## **Attachment B**

**Planning Proposal – 47-51 Riley Street,  
Woolloomooloo (as amended following public  
exhibition)**

# Planning Proposal: 47 – 51 Riley Street, Woolloomooloo

**Figure 19 15. Proposed maximum building envelope as amended following public exhibition – 3D view from the north east**

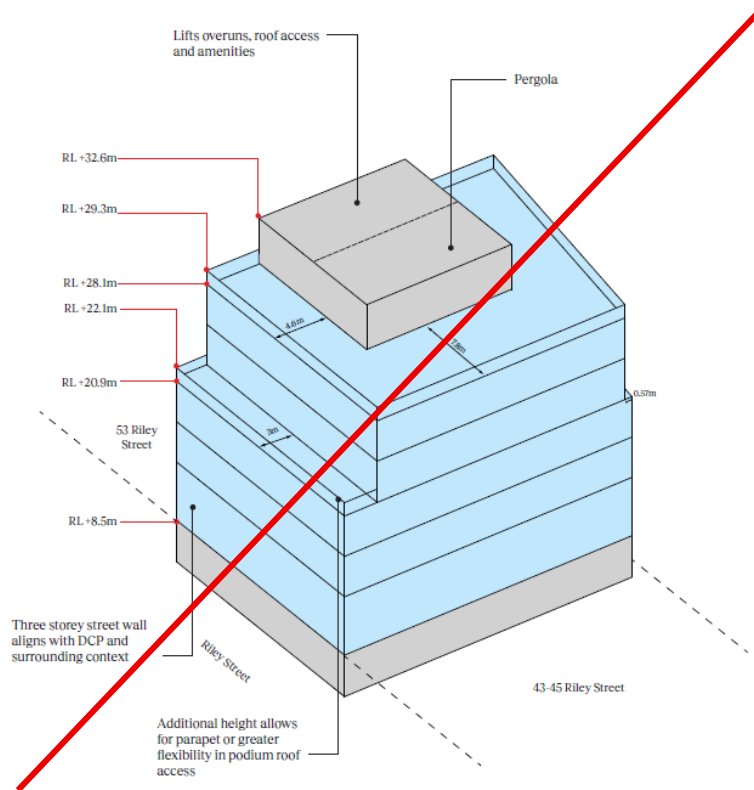
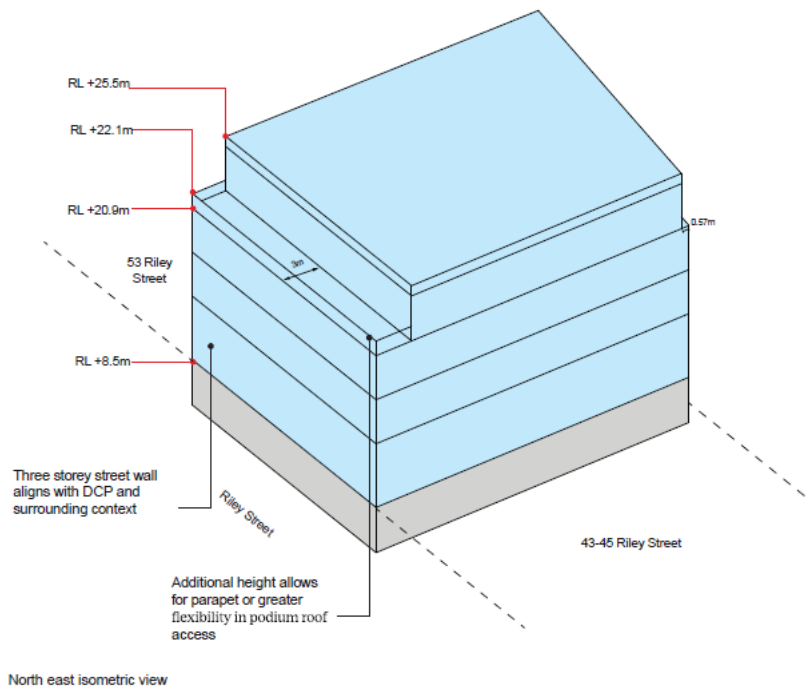
The proposed building envelope, as recommended to change post-exhibition, will allow a future building to respond to the context of the site. The proposal respects the scale of immediately adjoining properties through a podium, and with zero setbacks the building's edge will contribute to a cohesive streetscape form.

Figure ~~21~~ 17. Proposed maximum building envelope as amended following public exhibition – Riley Street elevation

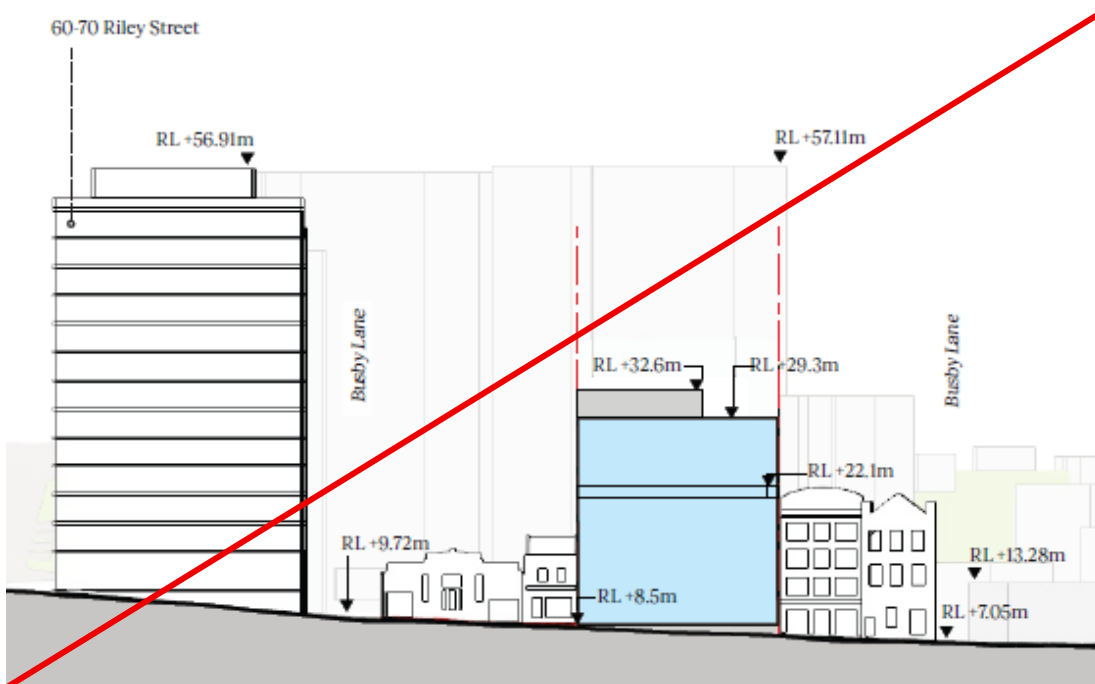
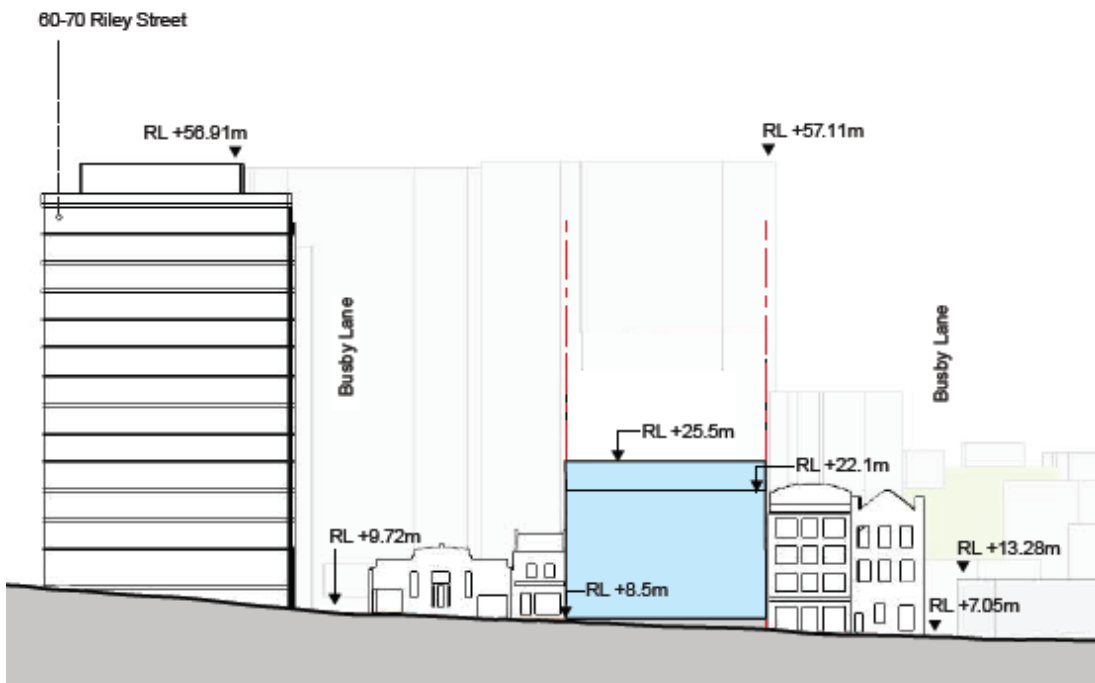
The planning proposal will insert a site-specific building height control in Sydney LEP 2012, which will be available to support the commercial redevelopment of the site. The increase in the maximum building height from 12 metres to ~~25 metres~~ **RL 25.5m** would facilitate the increase in FSR. Site-specific DCP controls will establish a maximum building envelope, demonstrating the maximum permitted height, along with maximum street wall heights and setbacks.

The proposed height of ~~25 metres~~ **RL 25.5m** is considered reasonable in the context of the site's surrounds. ~~The recommended height reduction from the exhibited planning proposal will result in a better relationship with neighbouring buildings within the street block.~~ The height is compatible with the diversity of building heights in the vicinity, including low and mid-rise buildings in the immediate street block and the high rise developments to the east, west and south of the site.

**Figure 23 19. Existing and proposed shadow impacts on residential façade of 60-70 William Street to the south (exhibited planning proposal)**

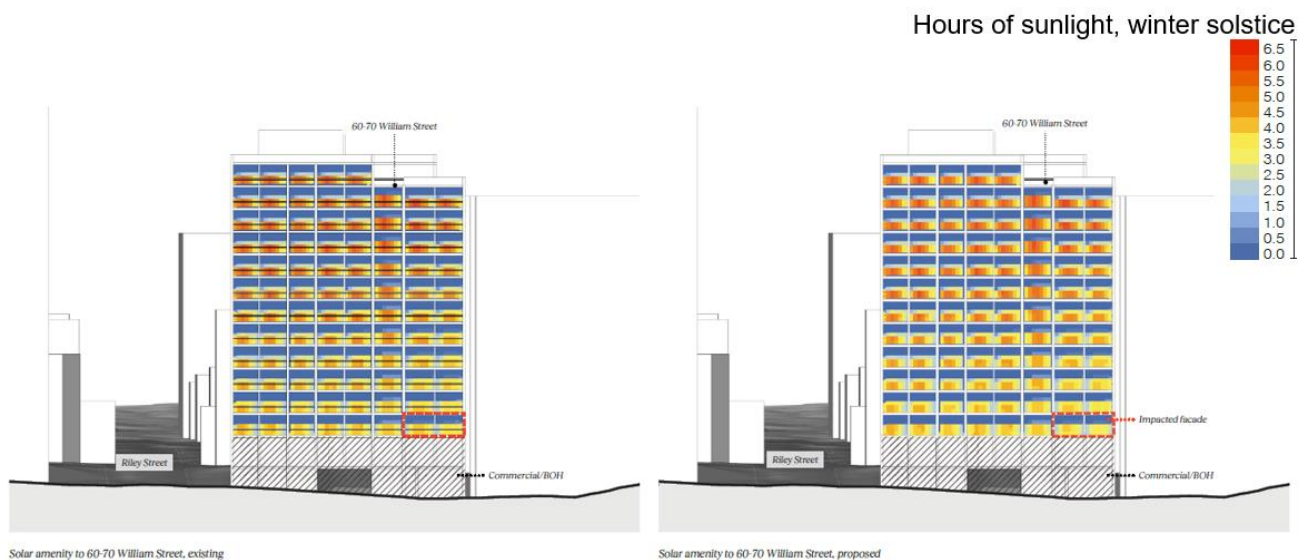
The building at 60-70 William Street which is a mixed use development with residential apartments located to the south of the site, required further investigation. Façade testing of the northern elevation of this building showed that only 0.5% of the residential façade would experience additional overshadowing impacts, but that all apartments would continue to achieve ~~two~~ 2 hours of solar access in mid-winter. Figure 23 shows the existing and proposed solar impacts of the development on the residential façade of 60-70 William Street.

The recommended post-exhibition changes to the planning proposal to reduce the maximum building height and FSR will also have the effect of reducing the shadowing impacts of the building envelope.

**Figure 25 23.** Ground floor plan of indicative design showing retail use and commercial lobby fronting Riley Street

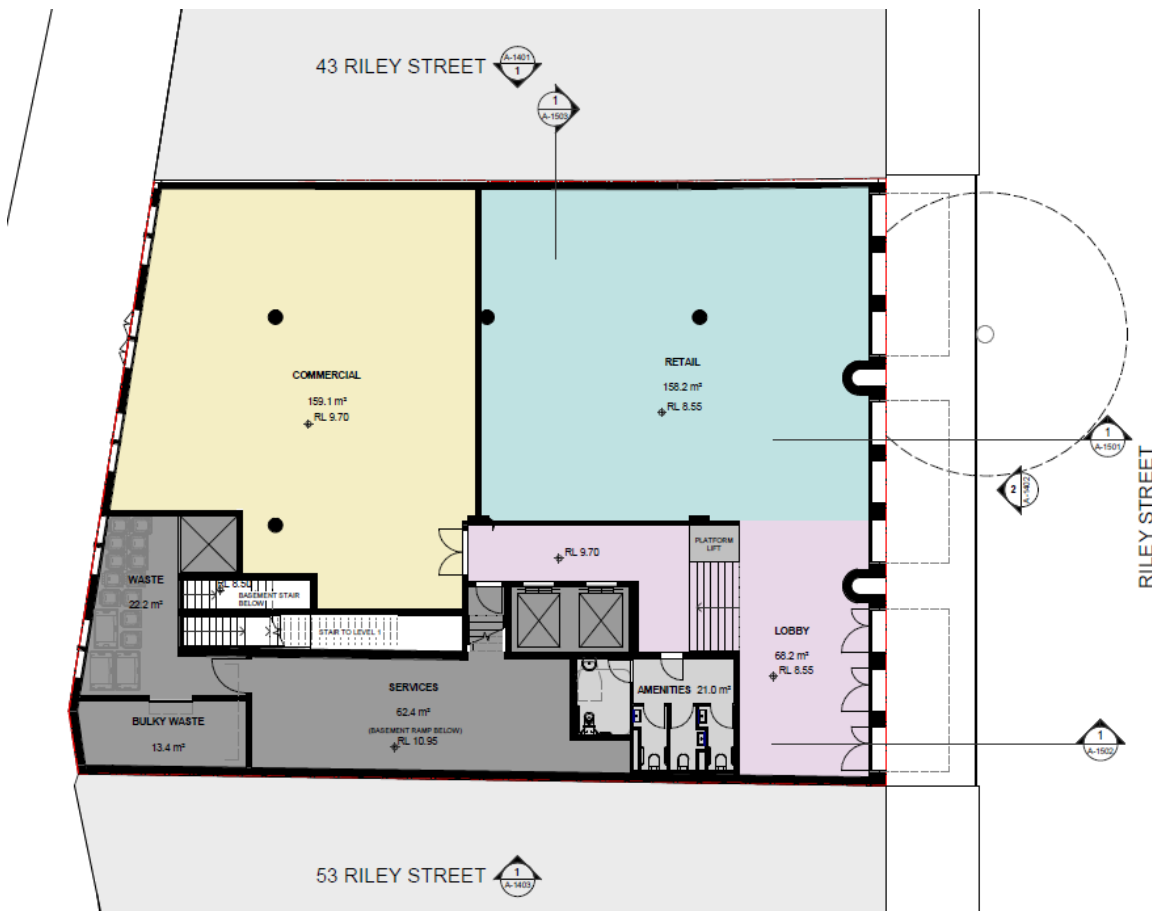
The City advised the proponent that the proposed floor levels for the retail and front lobby ~~are~~ in the indicative design were too low at RL 8.5m, and below the 10% Annual Exceedence Probability (AEP) for a flood event of RL8.85m and the 1% AEP for a flood event of 8.9m. The key concern at planning proposal stage was that addressing this may affect floor levels and therefore the overall height of the building envelope.

The proponent responded to this concern by raising the floor levels of the retail and front lobby area by 50mm, to a height of RL8.55m. The applicant advised that any future modification to lobby/retail levels would have no impact on the overall building height.

Following this amendment, the City's stormwater engineer has advised that the planning proposal is acceptable, but detailed Flood Impact and Risk Assessment (FIRA) and Flood Emergency Response Plan (FERP) reports are to be submitted in relation to future development applications relating to this site.
